Re: Omaha Public Power District
Fort Calhoun Station, Unit No. 1
Docket No. 50-285

As counsel for Omaha Public Power District, we hereby submit three (3) signed originals and nineteen (19) copies of a document entitled "Application for Amendment of Operating License", together with forty (40) copies of the proposed Technical Specifications. The application seeks to amend Sections 2.1.2 and figures 2-1A, 2-1B, 2-2A, and 2-2B of the Technical Specifications set forth in Appendix A to revise the reactor coolant system heatup and cooldown limits for operation through the end of fuel Cycle 8.

BEFORE THE UNITED STATES
NUCLEAR REGULATORY COMMISSION

FIGURE
2-1A

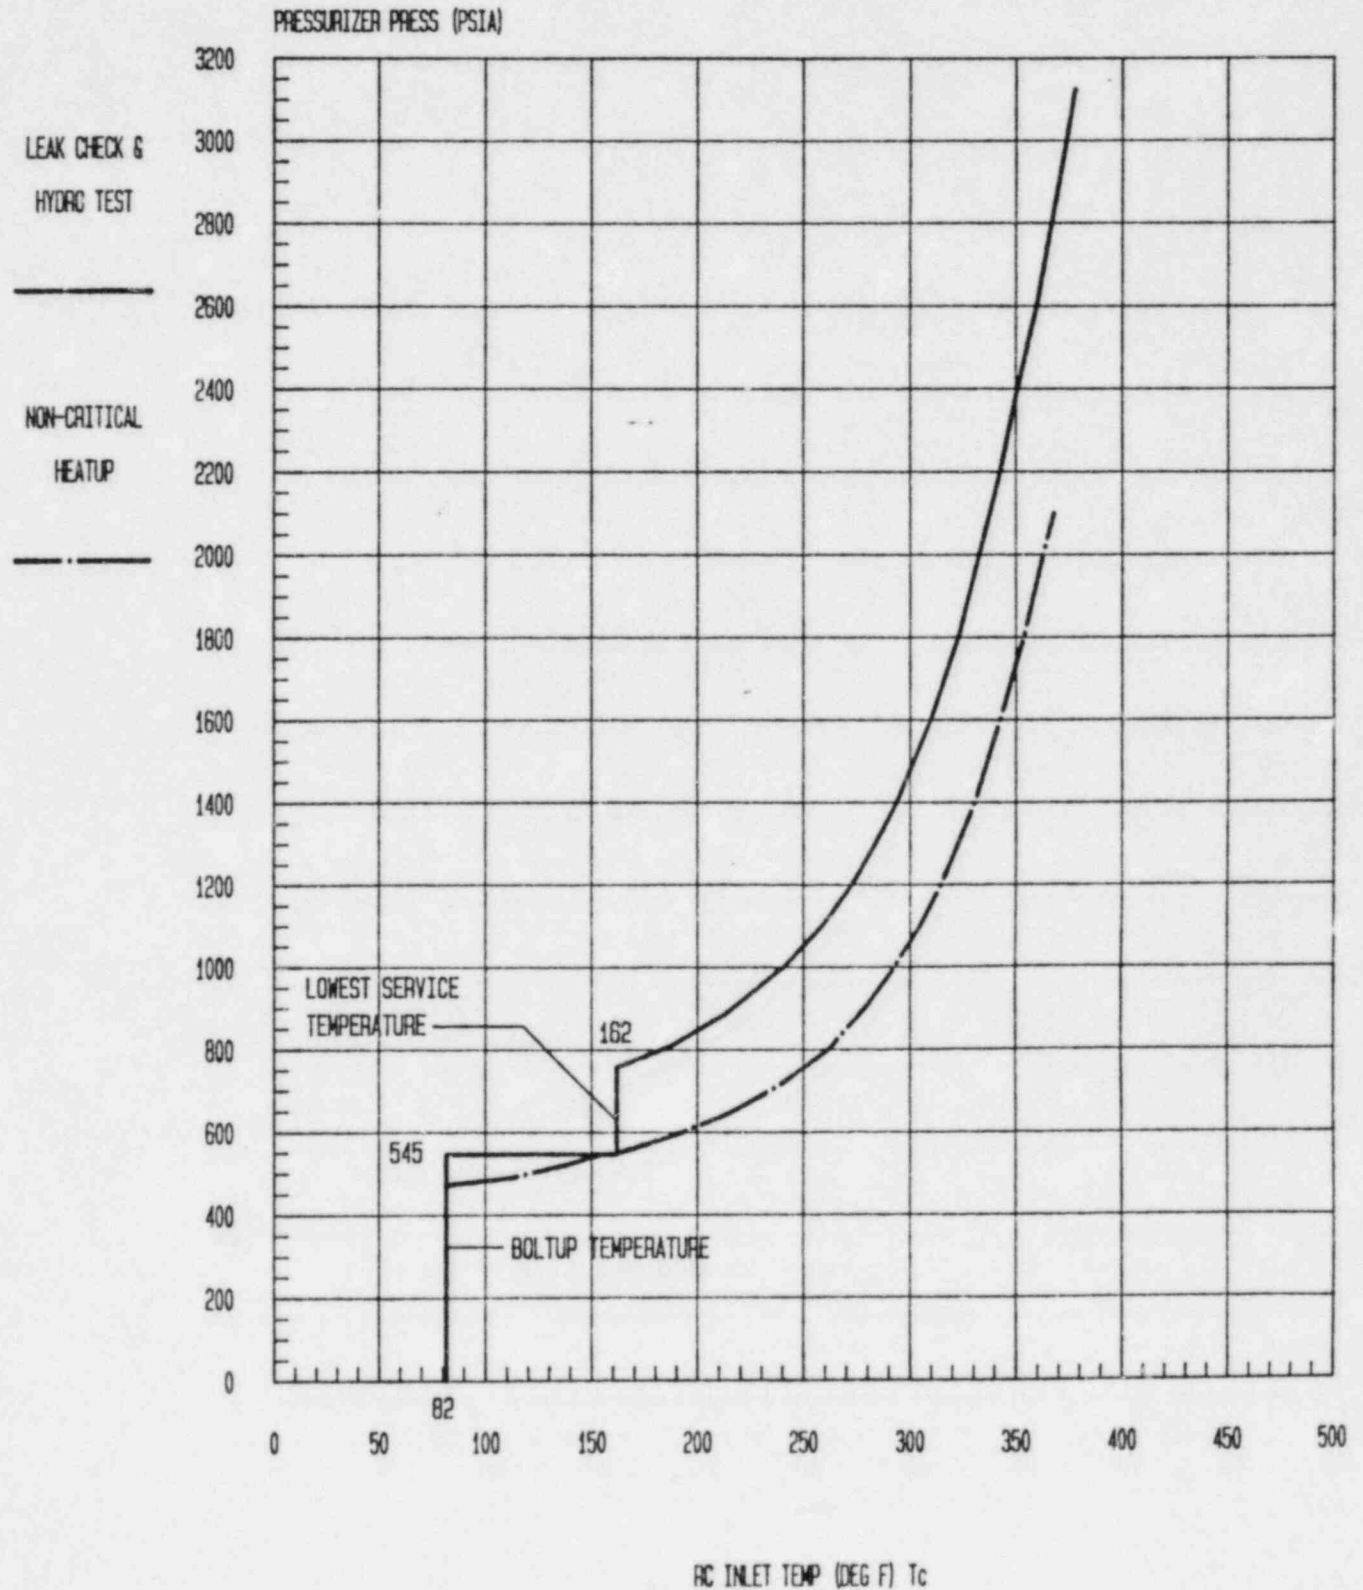
This amendment application is required to allow for the safe operation of the Fort Calhoun Station reactor and associated primary coolant system beyond the 6.1 Effective Full Power Years (EFPY) of operation for which the present Technical Specifications (TS) are valid. This application requests continued operation through 8.49 EFPY.

Regulatory Guide 1.99, Revision 1, provided the methodology used to determine the nil-ductility transition reference temperature (RT_{NDT}) shift reflected in the proposed heatup and cooldown limit curves. The fluence value for the reactor vessel belt-line weld material was determined using the end-of-life predicted fluence of $4.4 \times 10^{19} \text{n/cm}^2$. This value was calculated and approved for Cycle 6 operation using the Fort Calhoun Station first surveillance capsule test data as detailed in the Combustion Engineering report, "Evaluation of the Irradiated Capsule W-225", Revision 1, dated August 1980. In addition, the rate of fluence for Cycle 8 and future cycles was conservatively assumed to be 37% less than that of previous cycles due to the reduced fluence core loading pattern to be implemented for Cycle 8. Thus, the heatup and cooldown pressure-temperature limit curves used for Cycle 7 were updated to 8.49 EFPY without a temperature shift and yet still ensure adequate fracture toughness is maintained through all conditions of normal operation, including anticipated operation transients and system hydrostatic tests.

RCS PRESS-TEMP LIMITS HEATUP 8.49 EFPY
